Proposed Decision to be taken by the Portfolio for Transport and Planning on or after 13 September 2019

RUGBY FREE SECONDARY SCHOOL DEVELOPMENT TRAFFIC ORDERS

THE WARWICKSHIRE COUNTY COUNCIL (RUGBY BOROUGH) (CIVIL ENFORCEMENT AREA) (WAITING RESTRICTIONS, ON STREET PARKING PLACES AND RESIDENTS' PARKING) (CONSOLIDATION) (VARIATION F)
ORDER 2019

THE WARWICKSHIRE COUNTY COUNCIL (LONG FURLONG AND ANDERSON AVENUE, RUGBY) (20MPH SPEED ZONE) ORDER 2019

Rugby
Dunchurch Road / Kingsway
Proposed Waiting Restrictions
(Revised Road Layout) --/--/----/--/---

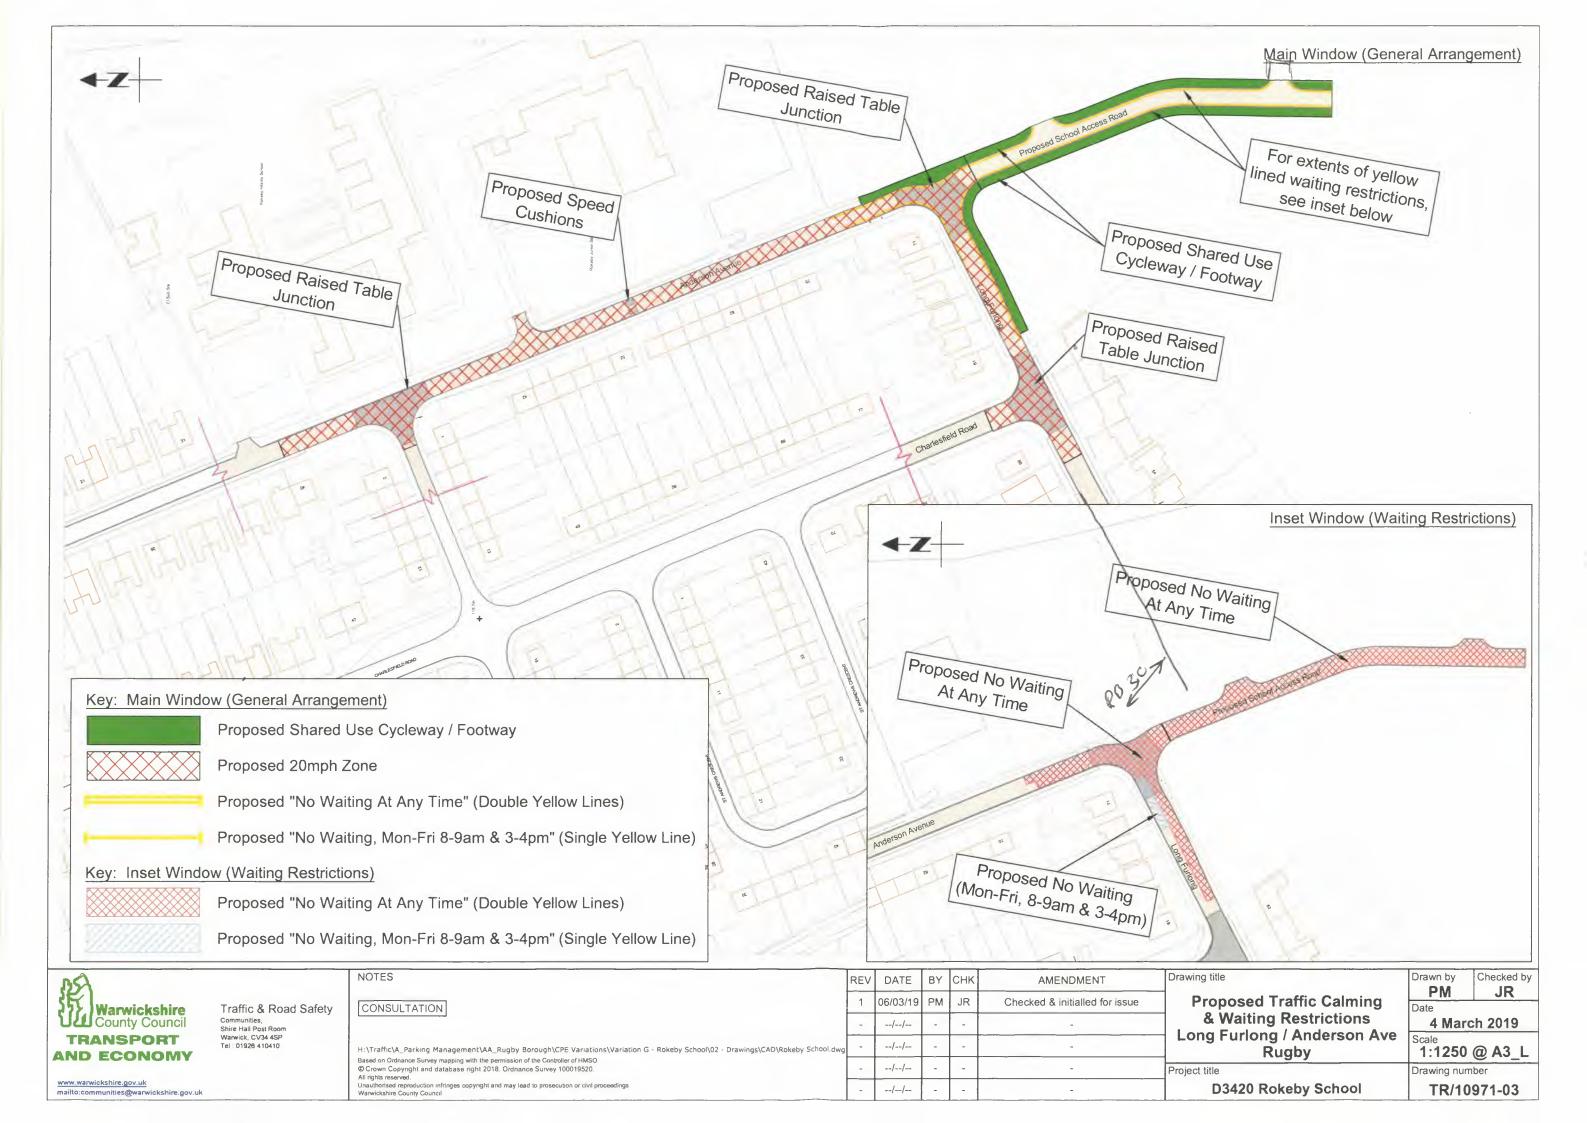
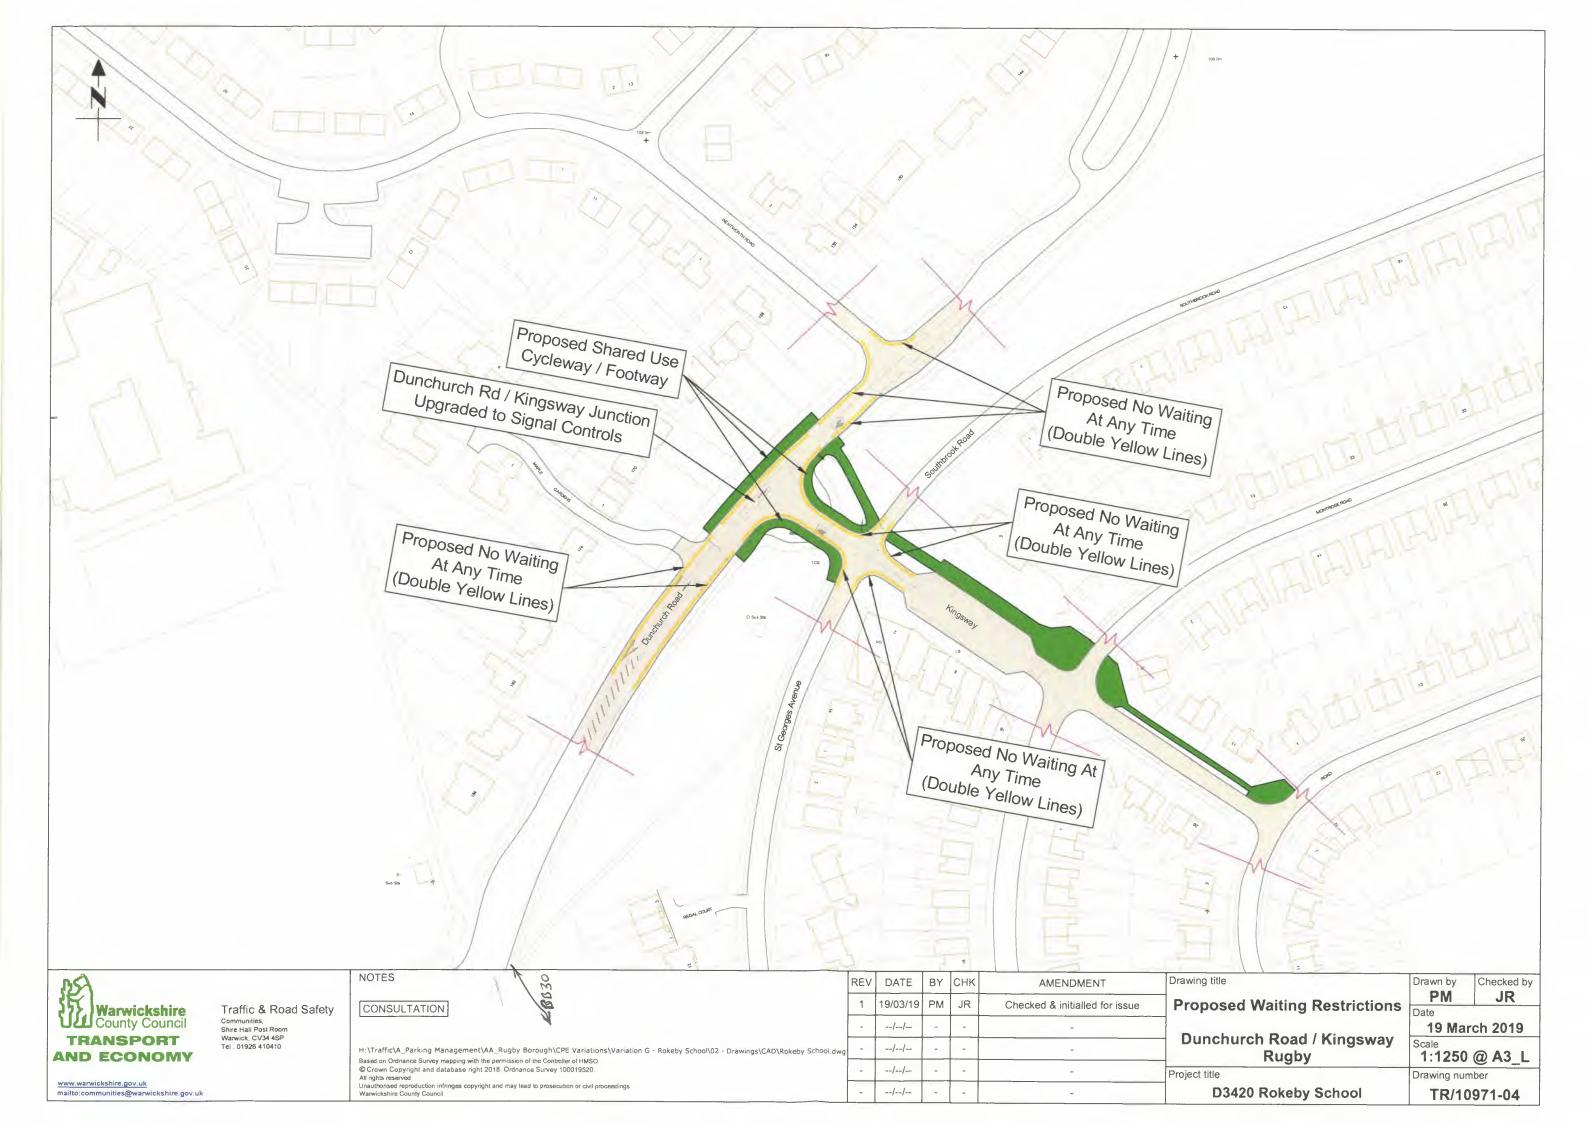
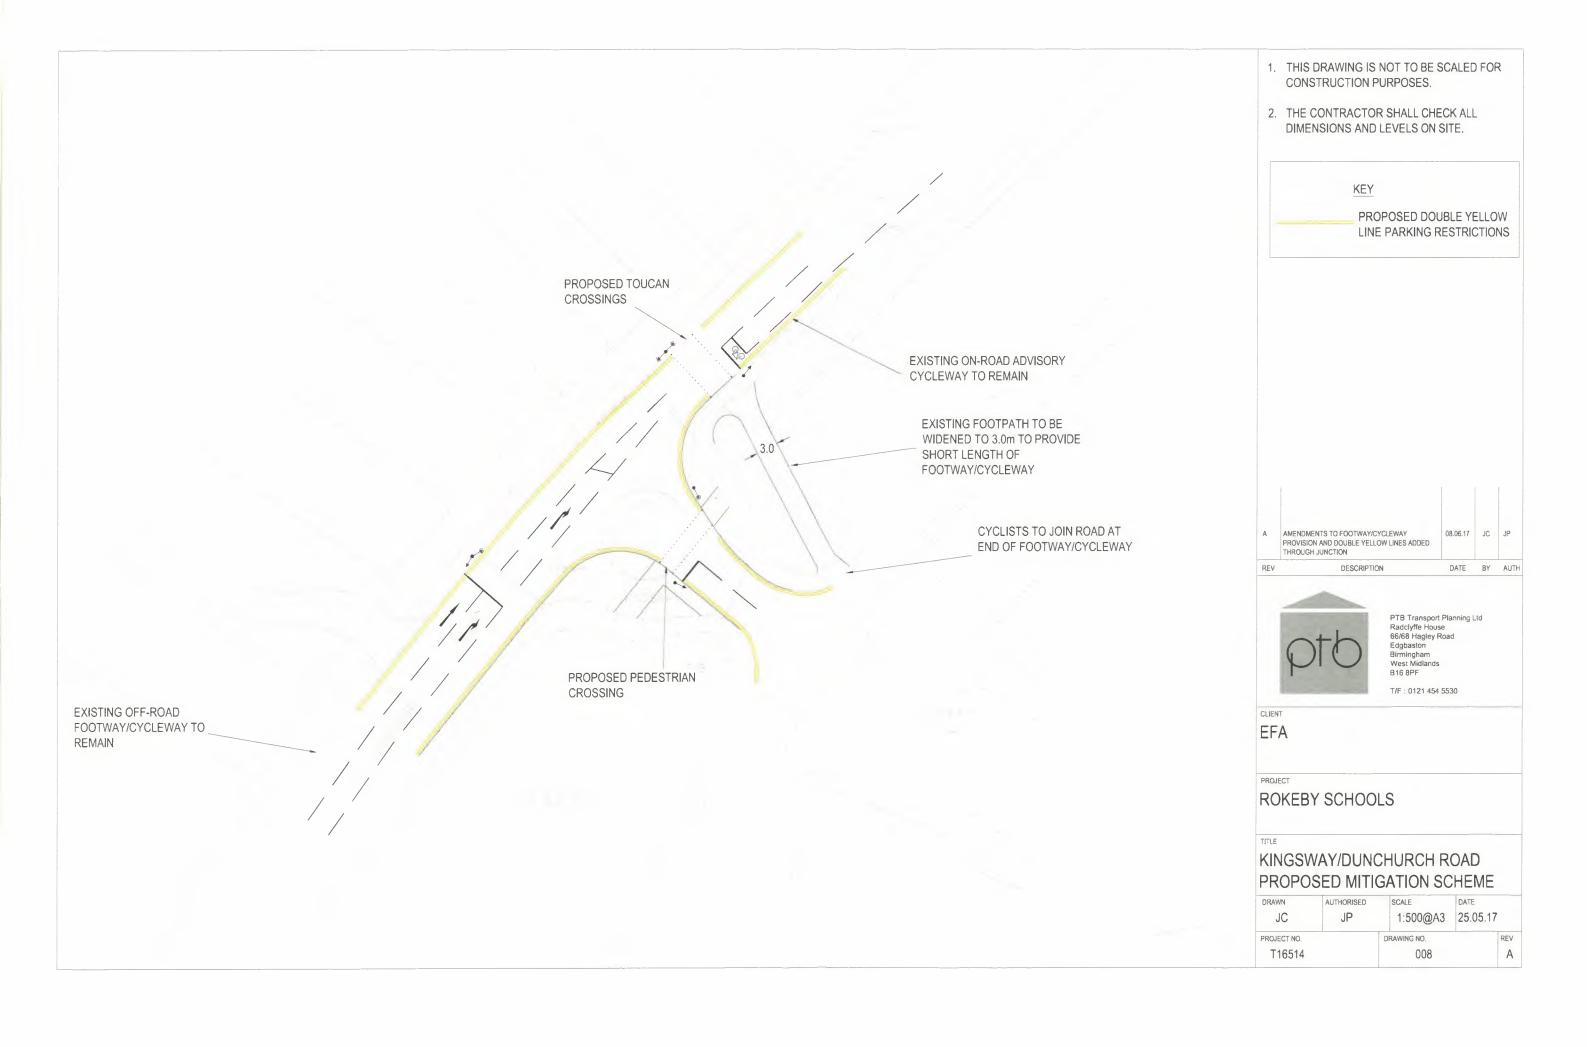
Email Ref	Support	
2	 a) The introduction of traffic lights at the Dunchurch Rd/Kingsway junction is welcome. b) The yellow lines and traffic calming measures are also welcome. 	
4	The introduction of road humps is supported.	
9	Support for the redesign of the Kingsway Junction.	
11	Overall plans are sensible and much needed. Traffic lights at the Dunchurch Rd/Kingsway junction are much needed. The proposed waiting restrictions are welcome.	
14	No issues with improved traffic management proposals

Email Ref	Objections	Response
	a) The only entrance to the school will not cope	a) The capacity of the junction is outside the scope of
1	with the vehicles, pedestrians and cyclists	this report but the 20mph zone and associated traffic
	forced to use it twice daily.	calming measures will maintain vehicle speeds at

b) Once a young cyclist leaves the school using this new cycleway/footpath, where does he/she go next?	low levels, sufficient to avoid collisions with pedestrians or other vehicles. The waiting restrictions around the entrance to the new school access road will also serve to protect forward visibility on the approaches to the junction. A priority give way junction was approved at planning stage. b) Provision has been made for cyclists to leave the school on a shared use cycleway/footway. On entering Anderson Avenue or Long Furlong cyclist will rejoin the carriageway via a dropped kerb. On both roads, the entry to the carriageway will take place into a 20mph zone self-enforced through the provision of road humps and raised tables. Speeds will therefore be low.
2	 a) Complaint re the works trucks using Long Furlong causing damage. b) Concern over the width of footways not being sufficient for shared use between cycles and pedestrians. 	 a) Out of scope of report. b) The shared use cycleway/footways will generally be 3.0m wide with the exception of localised pinch points where features such as trees or lighting columns may reduce the width. 3.0m is the preferred minimum width recommended by Local Transport Note 1/12, with a small buffer added where (as here) the cycleway/footway is bounded by a kerb. However, LTN 1/12 recognises that the width may be less than the preferred width according to the circumstances and that there may be pinch points along a route where the minimum dimensions cannot be met. Having regard to the road environment and the particular characteristics of the likely use, including the fact that pedestrians and cyclists are likely to be moving slowly and in the same direction at peak times, that usage will be very light at other times, that the ground is level, and that

vehicular traffic will be at low speed, the proposed widths are considered to be acceptable.
	a) WCC has suppressed the publication of <i>Rugby</i> Sustainable Transport Strategy. b) Incorrect placement of Overslade Lane	a) Out of scope of report.b) Out of scope of report.
	pedestrian crossing. c) Failed to secure funding from national government for a safe route for pupils from the	c) Out of scope of report.
3	e) WCC has failed to act on the recommendations of the non-motorised users	 d) The residential roads within the immediate vicinity of the site are quietly trafficked and speeds are generally low making it suitable for cyclists. Speeds are currently low and will, in fact, probably reduce owing to the proposed traffic calming measures and 20mph zone which is to be introduced. While conditions were already identified as favourable for cyclists at the planning stage, it was also recognised that additional measures would improve cyclist safety and make this mode of travel more attractive. e) The design incorporates uncontrolled crossing points for pedestrians. Separately, dropped kerb

audit which proposed uncontrolled crossings in Long Furlong and the segregation of pedestrians and cyclists within the school site itself.	access points for use by cyclists joining or leaving the shared use footway will be provided. The non-motorised user audit (NMUA) recommendations to provide a segregated route within the school site if possible are outside the scope of this report. f) There is no proposed shared use cycleway and

f) Criticism of the proposed cycle route along Belmont Road.	footway on Belmont Road. There are short sections of shared use footways on Long Furlong and Anderson Avenue and a longer section running from the junction of Belmont Road and Kingsway to Dunchurch Road. g) See comment above in 2(b).

Overslade Lane. Concern over the design of the shared use footways/cycleways which may not be wide enough for pedestrian and cyclist use.	b) See comment 2(b) above.

i) j) k)	The design of the shared cycleway and footway is flawed. Criticism of lack of a roundabout at the Long Furlong/Anderson Avenue junction and provision instead of a T-junction. Criticism of how cyclists will transition from the shared footway/cycleway onto the carriageway in Anderson Avenue and Long Furlong. Query over the width of the proposed shared use footway. Will it be wide enough? WCC has provided no reasons for converting pavements into shared use footways and cycleways. Criticism of layout of pedestrian refuge in	 h) This is outside the scope of this report but in any event the proposals reflect those previously approved at the planning stage. i) Cyclists will transition from the shared use footway/cycleway onto the carriageway and vice versa via dropped kerbs at the start/end of the designated shared use sections of footway. These transition points will be located within the 20mph zone where traffic will be calmed to reduce speeds and where waiting restrictions will prevent the build up of parked vehicles which might affect visibility and access. Separate uncontrolled crossing points will be provided for pedestrians. j) See comment 2(b) above. k) Sustainable Transport Note 03 05 17 contained within the planning application documents refers to additional cycling trips being generated as a result of the school development. The promotion of cycling and walking as preferred forms of sustainable transport options is a central aspiration of WCC's existing Local Transport Plan. By taking cyclists off the carriageway, safety and user confidence are expected to be improved. Segregated cycleways are not practicable because of space constraints. a) Out of scope of report

c) Cycle safety audit – WCC has not adhered to recommendations	 c) WCC has noted the recommendations of the NMUA which considers cyclists. The NMUA and the designer's response to it are included as Appendix C. The consulted upon proposals considered the NMUA recommendations and the response to them. Also refer to Objection 3(e) and the response above.

d) Criticism of length of double yellow lines along frontages in Anderson Avenue.	d) Double yellow lines will not be implemented across the front elevation of any residential property adjoining Anderson Avenue. The waiting restrictions will be limited to a small area around the junction into the new school access road. This is in line with other junction protection measures in place at various junctions within the county to improve visibility.

a) New crossing on Dunchurch Road is abysmal.b) What logic is behind shared use footways?	a) Out of scope of this report. b) See comment 3(k) above.
5	c) The cycleway designs get students to the most dangerous part of the road where they are expect to rejoin.	c) Cyclists will rejoin the carriageway via dropped kerbs which will allow them to re-enter the road in a 20mph zone self-enforced through the provision of road humps and raised tables, where visibility will be improved through the prevention of parking by new waiting restrictions.

d) Cyclists should not be expected to stay safe by using a footway which is too small to be shared use. 	d) See comment 2(b) above.
6	 a) Raised tables and road humps are a waste of money because speeds are already low. 	 a) The 20mph zone requires traffic calming measures so that it is, in effect, self-enforcing. The introduction

d) The proposed lengths of cycleways are no use at all because pupils will have to travel on unprotected roads until these cycleways are reached. 	 d) It is acknowledged that it is not possible to provide shared use cycleways and footways for the entire length of the approaches to the new schools. However, the proposed measures will improve on the existing conditions for this route to the new school.
7	e) The proposed 20mph zone does not extend far enough into Long Furlong.	e) There are no plans to extend the 20mph zone at the present time but, as with all WCC road schemes, the proposed measures will be kept under review.

8	Strongly object to the cycleway. It has safety problems and we believe that the pavement is not wide enough.	See comment 2(b) above.
9	Will the design for the Kingsway/Dunchurch Rd traffic light junction include a right turn filter light?	There is currently no intention to introduce a separate right turn phase in the proposed signalling arrangements. However, the junction will be kept under review and a right turn phase may be provided if necessary.

- The shared use cycleway/footway is not wide enough for this usage
 - The shared use cycleway/footways will generally be 3.0m wide with the exception of localised pinch points where features such as trees or lighting columns may reduce the width. 3.0m is the preferred minimum width recommended by Local Transport Note 1/12, with a small buffer added where (as here) the cycleway/footway is bounded by a kerb. However, LTN 1/12 recognises that the width may be less than the preferred width according to the circumstances and that there may be pinch points along a route where the minimum dimensions cannot be met. Having regard to the road environment and the particular characteristics of the likely use, including the fact that pedestrians and cyclists are likely to be moving slowly and in the same direction at peak times, that usage will be very light at other times, that the ground is level, and that vehicular traffic will be at low speed, the proposed widths are considered to be acceptable and did not give rise to concerns in the Safety Audit or the NMUA.

- How will cyclists transition safely from the cycleway onto the carriageway?
 - Cyclists will transition via dropped kerb arrangements into a 20mph zone where traffic is calmed by road humps and raised tables and waiting restrictions will aid visibility.
